WAR MEMORIAL FIELD IMPROVEMENTS PHASE I

ADDENDUM NO. 2

DATE: March 6, 2020

3 TYP BACK STOP POST DETAIL
SCALE: 3/4" = 1'-0"

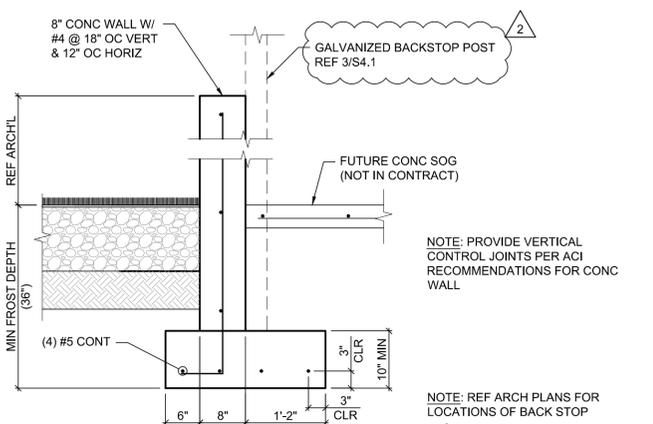
Revise Baseball Backstop Netting Post Footing Depth to 13’-6” and Line Post size to 12-3/4” O.D.

Revise Softball Backstop Netting Post Footing Depth to 13’-6” and Line Post size to 12-3/4” O.D.

Replace Keynote 2 on Detail 3, Backstop Netting Post, Sheet L6.3 to read as follows:

“Galvanized Steel Pipe (30’ Softball post height, 40’ Baseball post height) See Structural Detail 3/S4.1.” Replace Footing Depth and Post Size reference “12’-6” min. @...” to read as “See Structural Detail 3/S4.1 Typ Backstop Post Detail”.
